Environmental Authority P-EA-100421677 Amendment Application

I refer to your information request received on 20th April 2026 in relation to this EA amendment application.

Figure 1 – shows the potential areas to be mined with the 200m buffer zones in pink

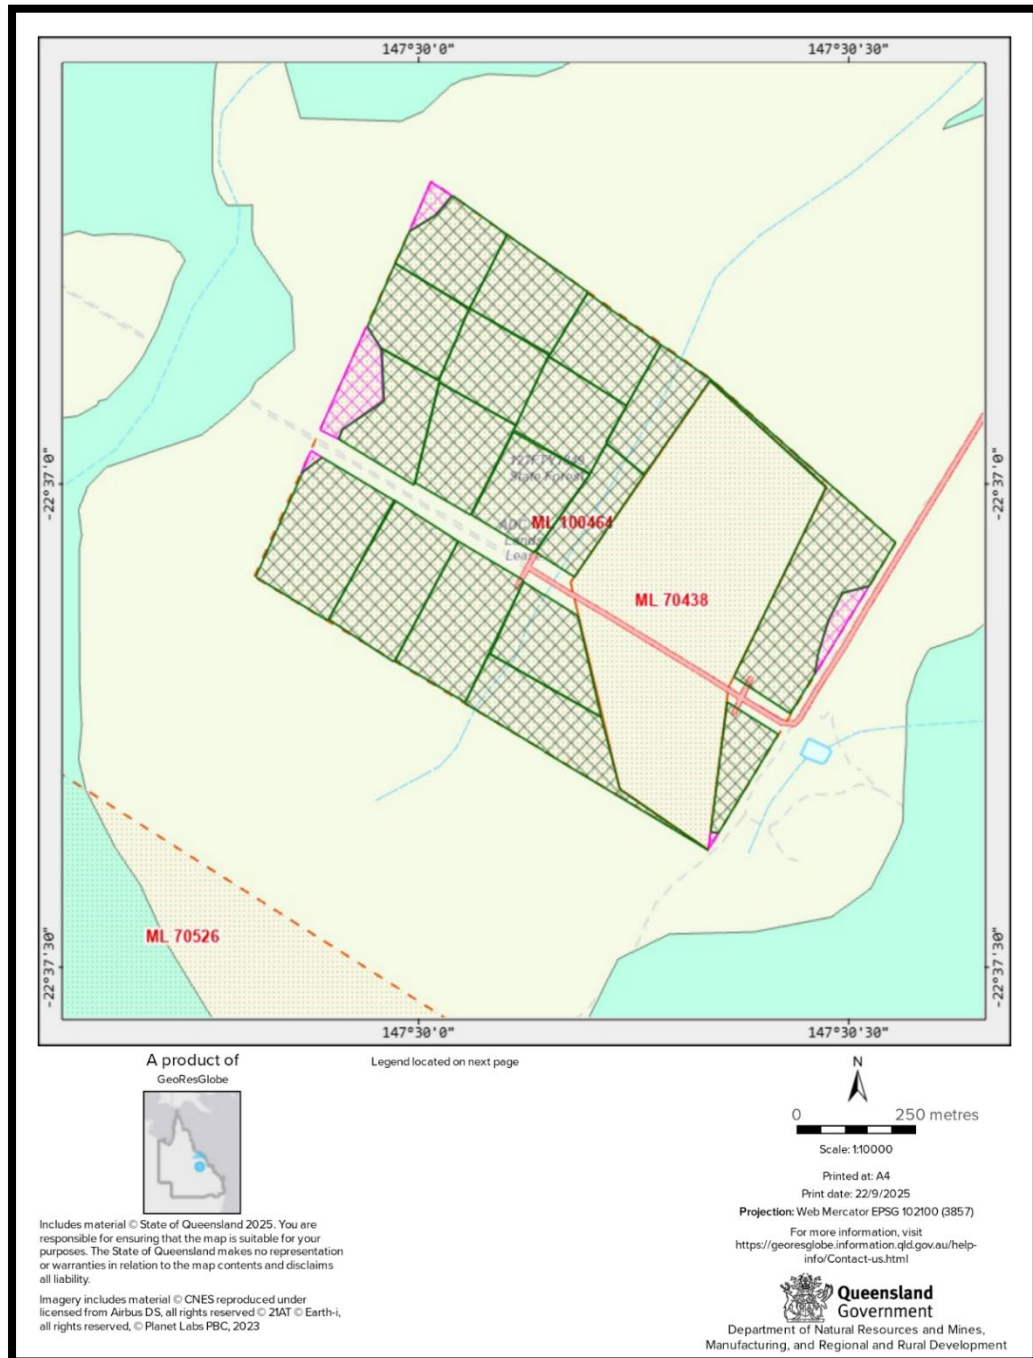
1. Category B environmentally sensitive area (ESA).
 - a. Indicate where activities will be undertaken in relation to the Category B ESA known as ERE 11.4.8/11.11.2 and confirm the buffer distance from the Category B ESA.

- b. Considerations of the potential impacts on the Category B ESA known as ERE 11.4.8/11.11.2.

- c. Management strategies to reduce the impact from mining activities on the Category B ESA known as ERE 11.4.8/11.11.2.

Response: Figure 1 shows the potential mine areas at the closest point to the ERE from the western boundary measuring approximately 108m. Note the area is variably mineralised with runs of gold bearing material more likely to be found in the deeper soil/gravel profiles. It is unlikely that the whole area of the mining lease will ultimately be mined, however the areas to be mined cannot be predicted with any certainty until operations begin. It must therefore be assumed that the whole of the mining lease area will be mined at this stage.

Response: The land slopes gently in a north westerly direction from the western mining lease boundary with a fall of no more than 10m in 300m. Discharge of sediment and/or dirty water if unchecked could flow in a north westerly direction and potentially impact on the mapped ERE areas to the west of the mining lease boundary. Any flow in the direction of the ERE would however be impeded by the current heavy vegetation, following a record-breaking wet season. Any flow would be unlikely to impact on the ERE in the current situation. In other circumstances following drought conditions and/or fires, flow of sediment and/or dirty water could potentially reach and impact the ERE.

Response: The intention is to ensure care is taken in mining areas within 200m of the ERE areas denoted in pink hatching. These areas will only be mined in the dry season between May and October and rehabilitation will be completed before 30th November each year. Mine excavations will be relatively small with areas of 50m x 50m.

In all cases the overburden will be placed around the downslope side of each excavation such that run-off is contained and not allowed to flow outside of the mining lease boundary and certainly not in the direction of the mapped EREs. Clean water would be diverted from the upstream side of any disturbed areas effectively reducing the volume of affected water that would need to be contained within open excavations.
